CITY OF ALBUQUERQUE

Re: Caterpillar Clubhouse
803 2nd St. SW
Traffic Circulation Layout
Architect's Stamp xx-xx-xx (K14-D227)

Based upon the information provided in your submittal received 04-27-22, the above referenced plan cannot be approved for Building Permit until the following comments are addressed:

TRAFFIC CIRCULATION LAYOUT

A3 ENLARGED RAMP DETAIL
SCALE: 1" = 8'-0"

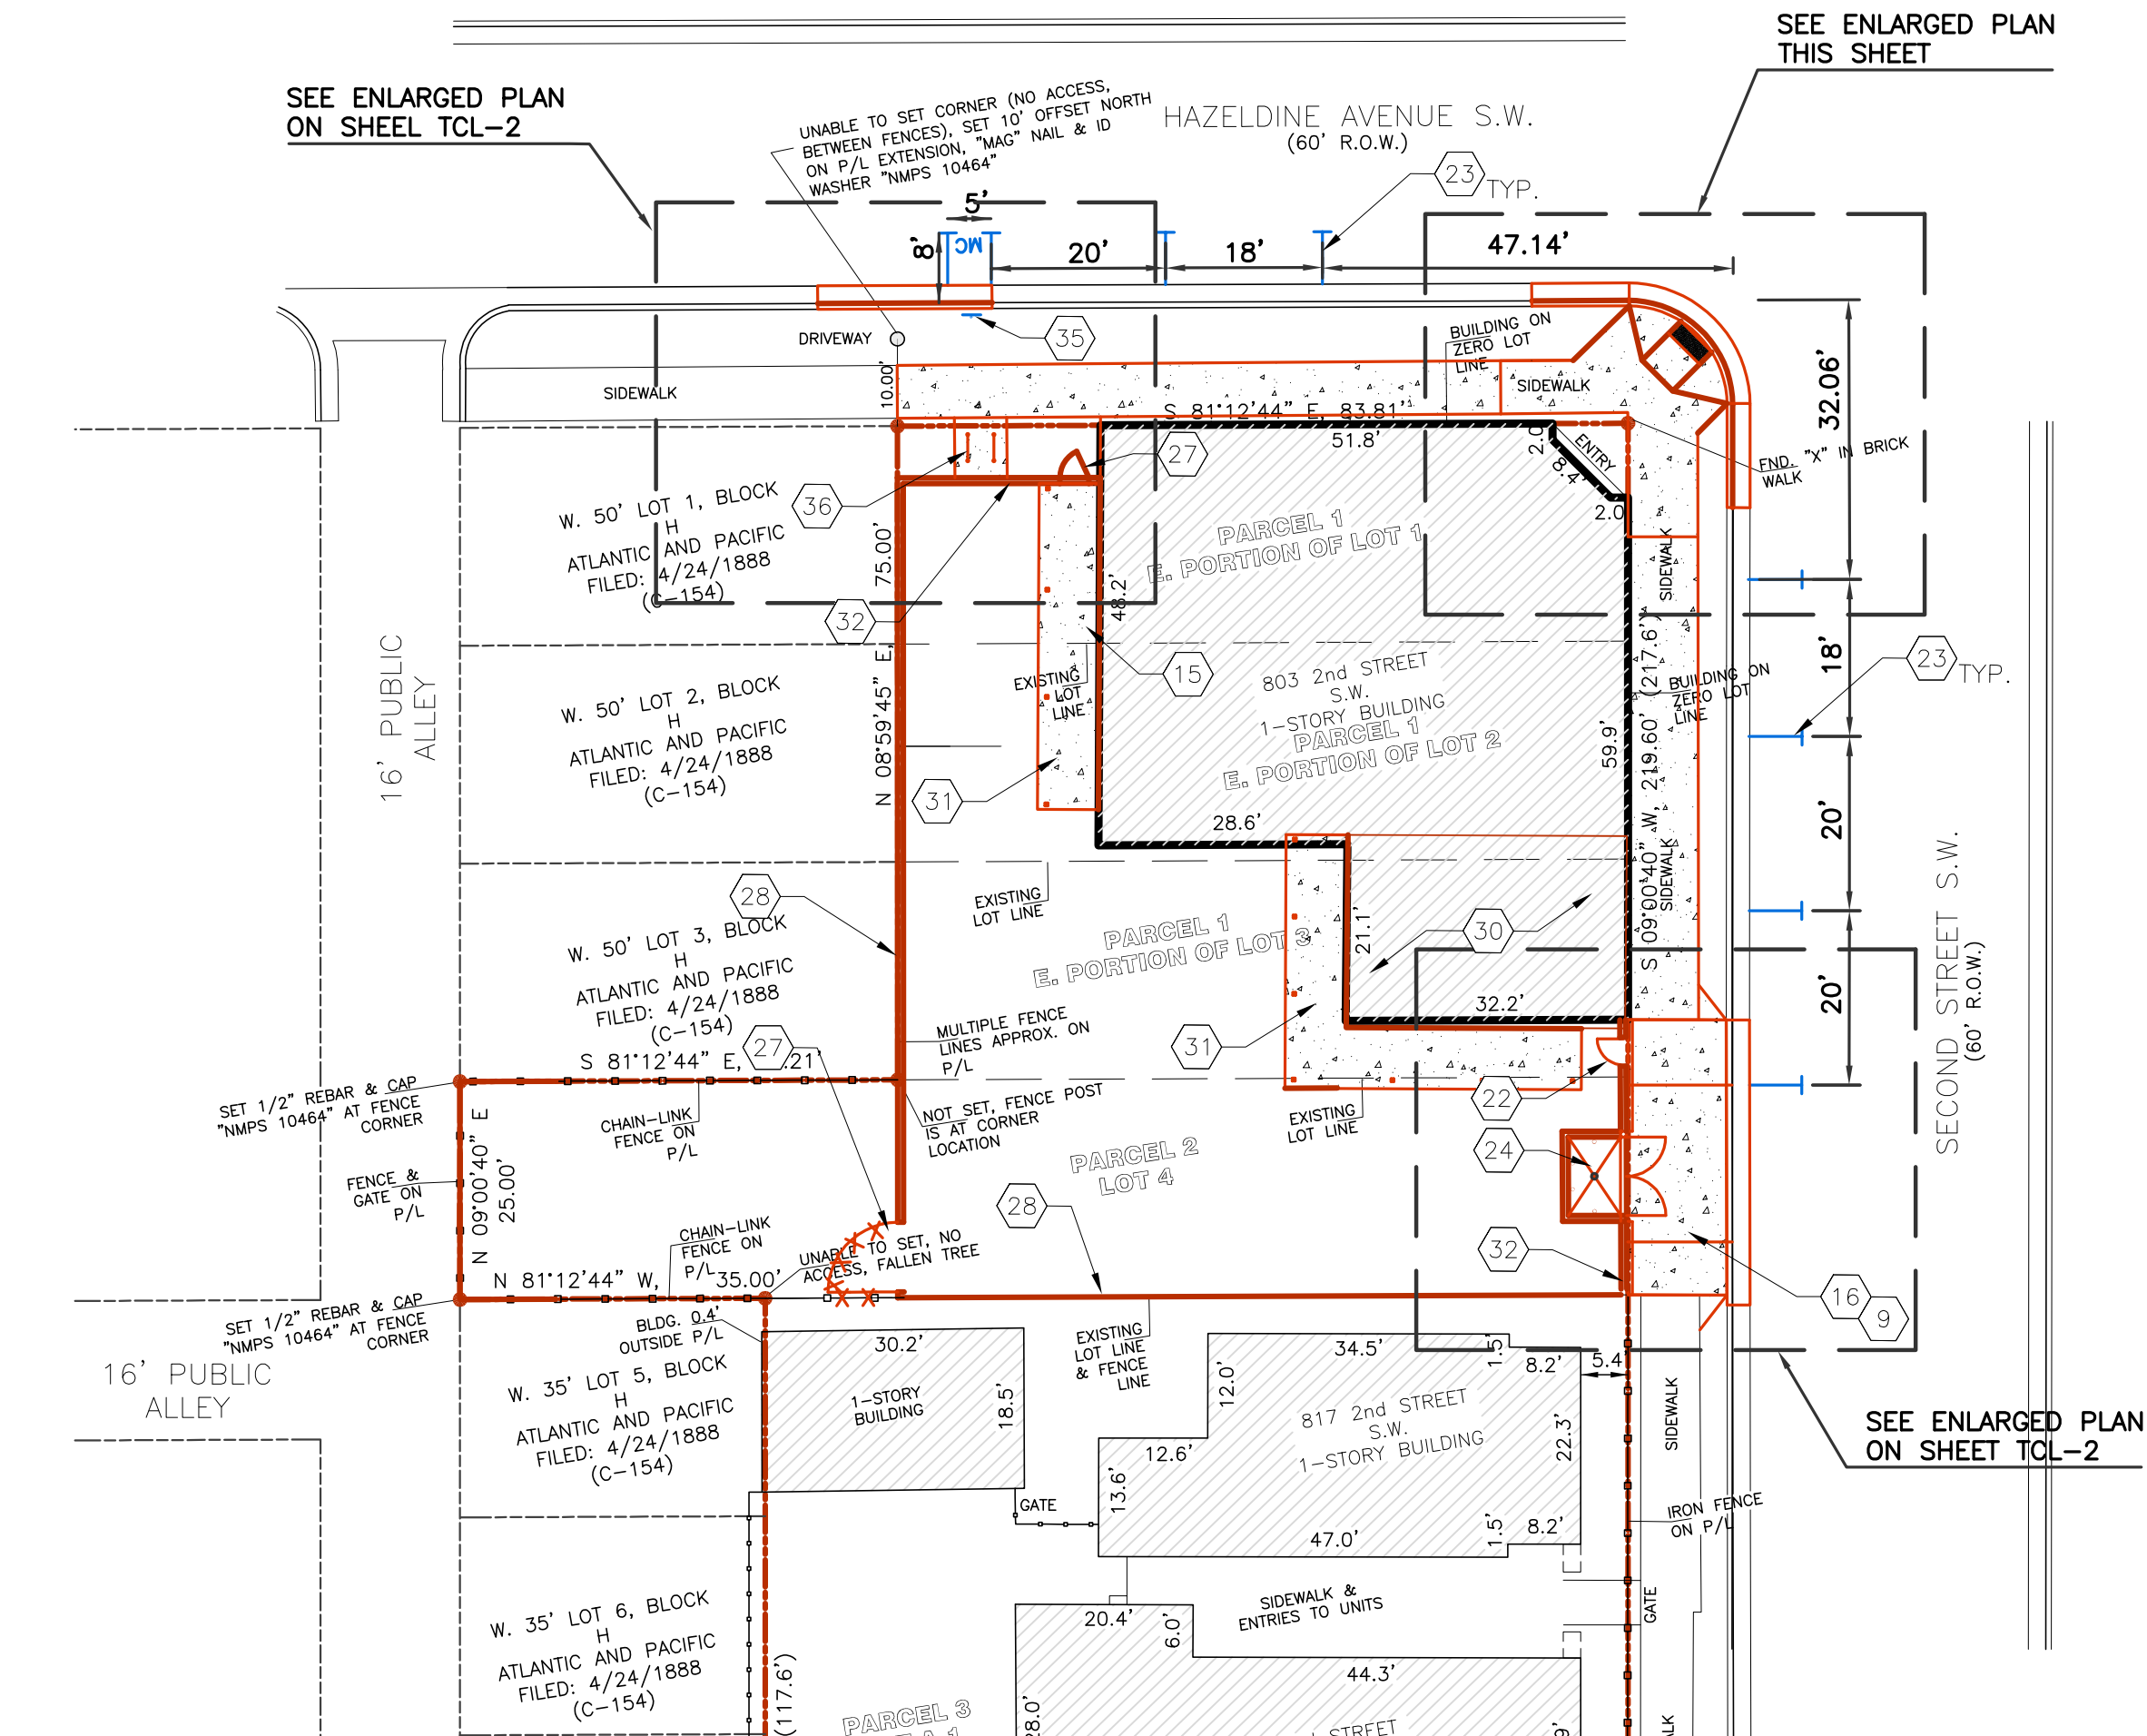
1. The traffic circulation layout must be stamped, signed, and dated by an engineer or architect licensed in the state of New Mexico.
2. Please see attached revised ADA ramp at the corner of 2ND St. and Hazeldine Ave. Remove the blue flared sides and keep the green flared sides to avoid a tripping hazard. Please note that flared side are to have a slope of 10% max. Also, provide 5'X5' landing area with 2% max. slope, ramp dimensions, and sidewalk easement as needed.

A1 TRAFFIC CIRCULATION LAYOUT
SCALE: 1" = 20'-0"

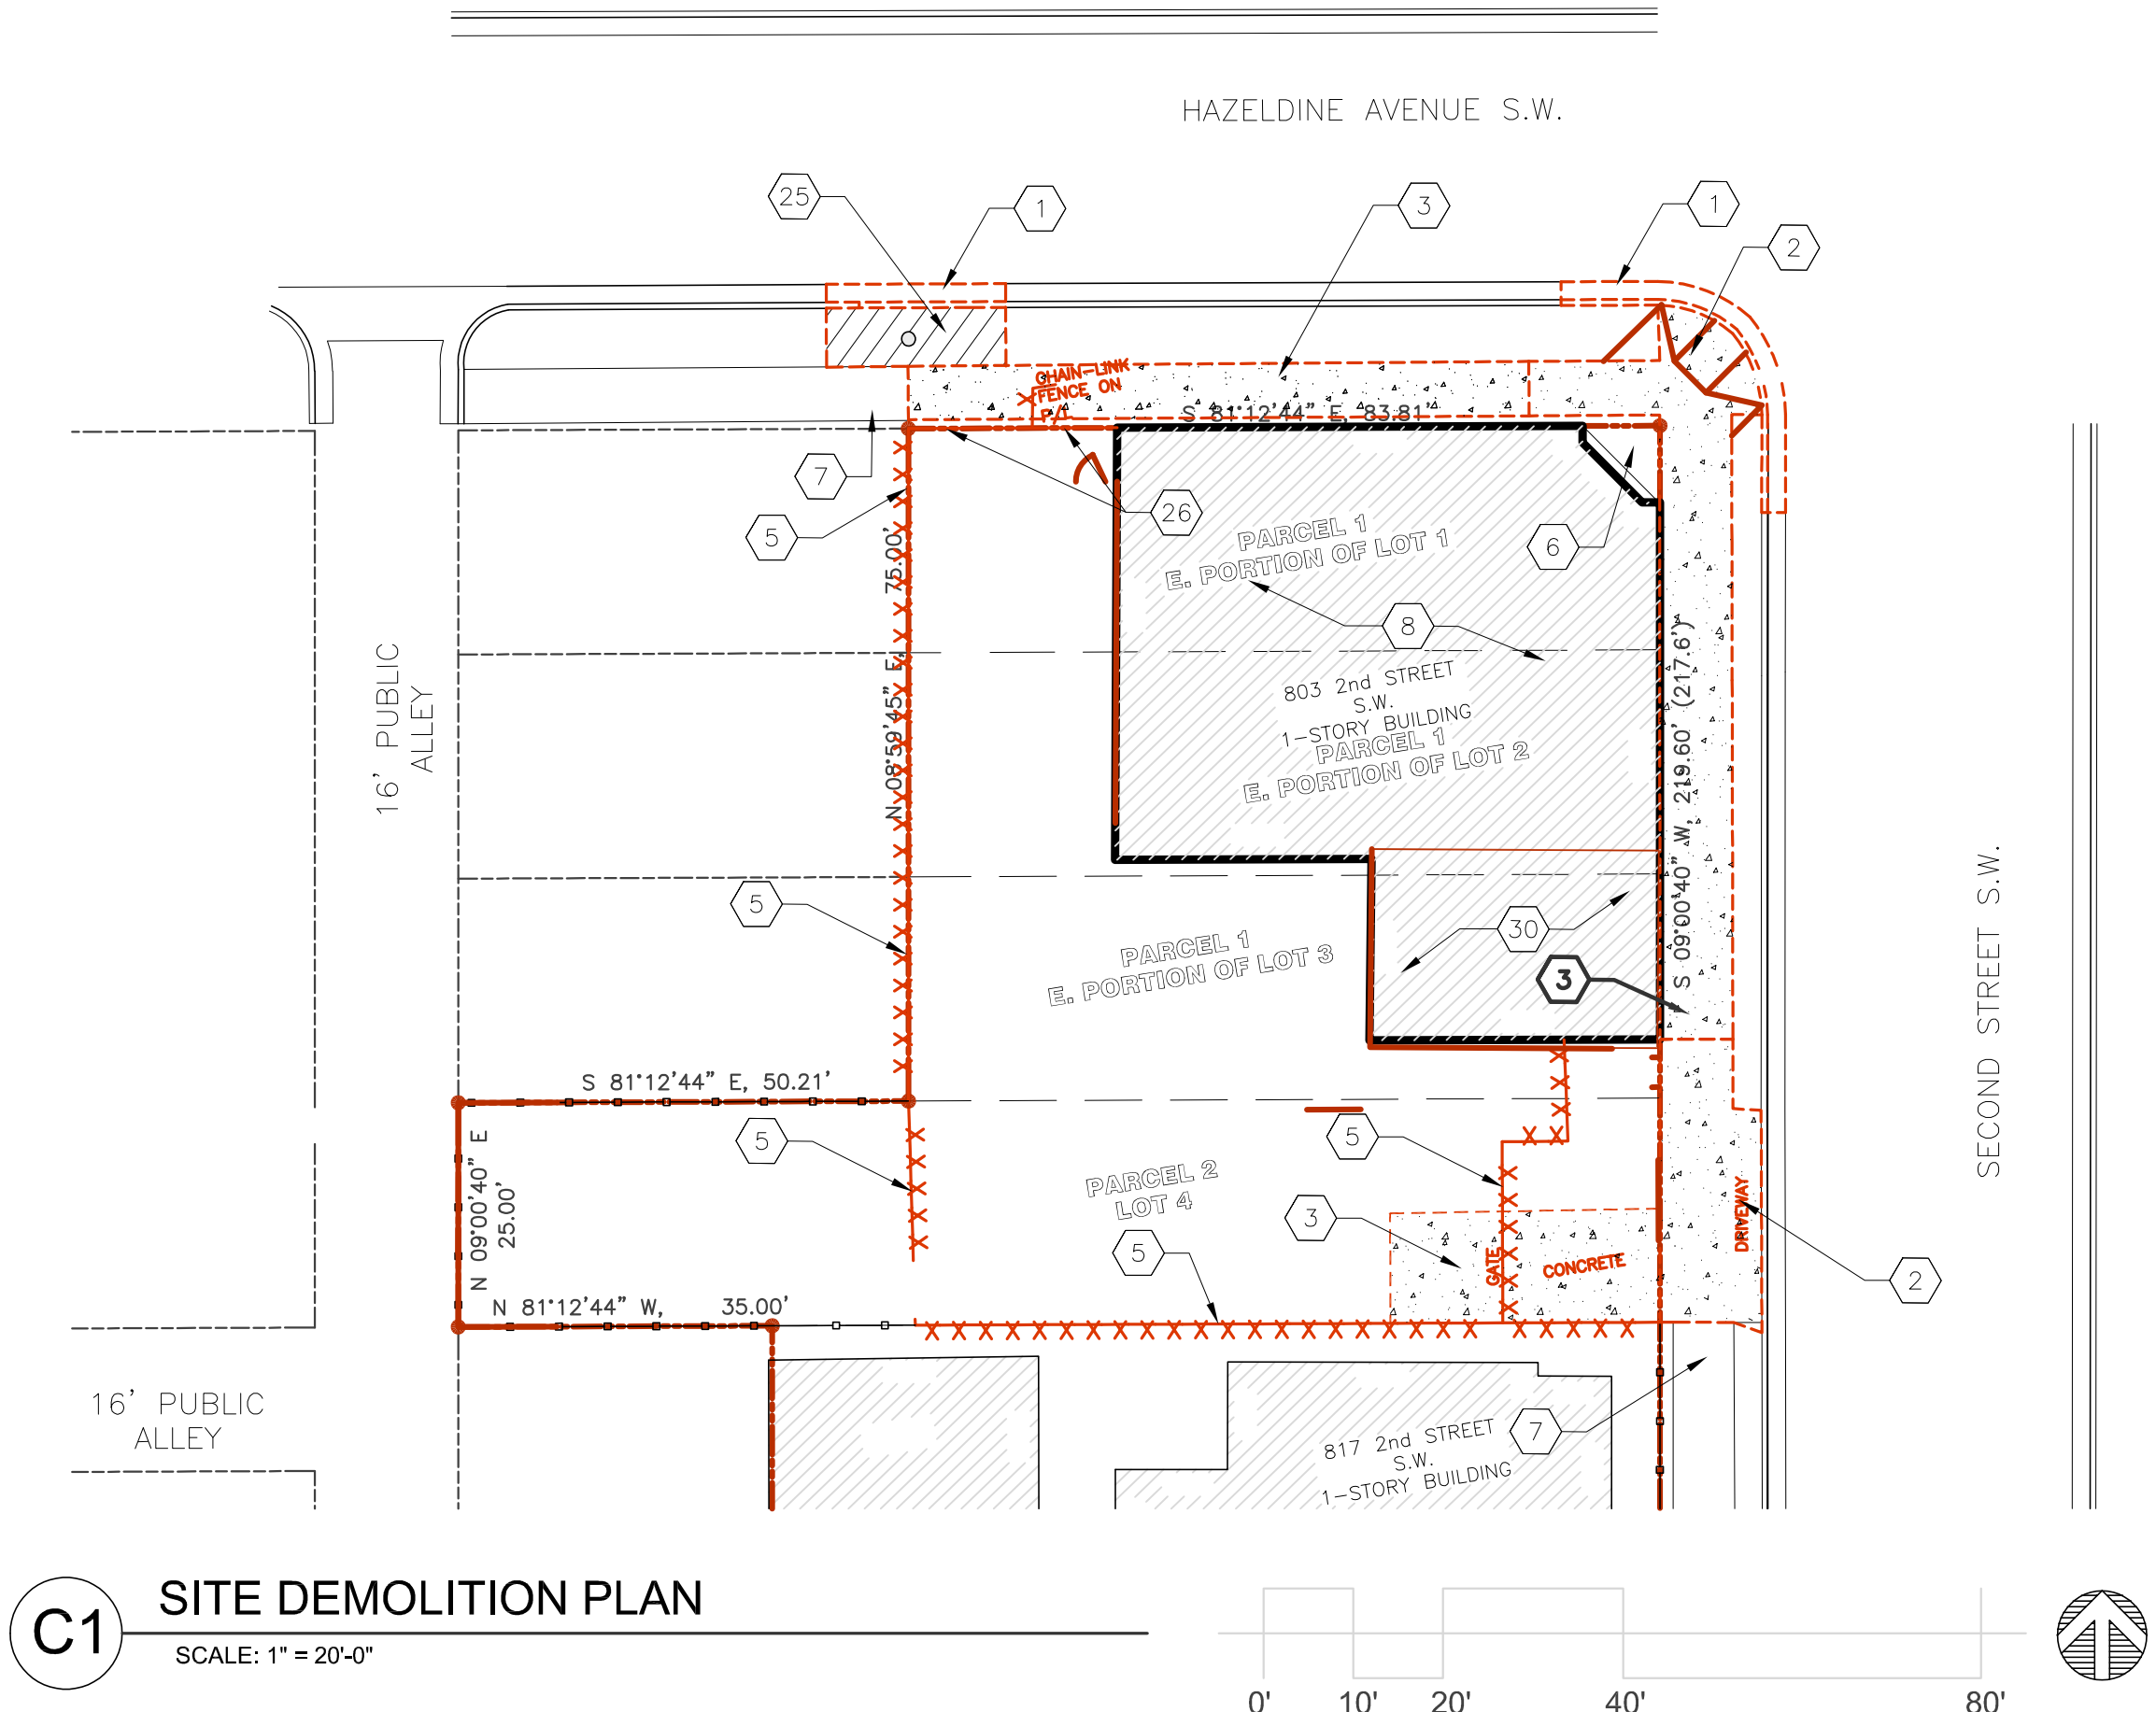
3. Provide the 2nd St. driving Lane's width and Hazeldine Ave. Lane's width. To determine if there are adequate spaces for on-street parking.
4. Show on site plan 6' ADA pathway from ADA aisle (for the new ADA parking) to the building entrance.

6. Please relocate the ADA parking space to Lot 4 (IF APPLICABLE). Transportation is OKAY with ADA parking off Alleyway.
7. The ADA access aisles shall have the words **"NO PARKING"** in capital letters, each of which shall be at least one foot high and at least two inches wide, placed at the rear of the parking space so as to be close to where an adjacent vehicle's rear tire would be placed. (66-1-4.1.B NMSA 1978)

10. It is not apparent what type of pavement surface is being proposed. A hard driving surface will be required as part of this proposed project for parking area and drive aisles.
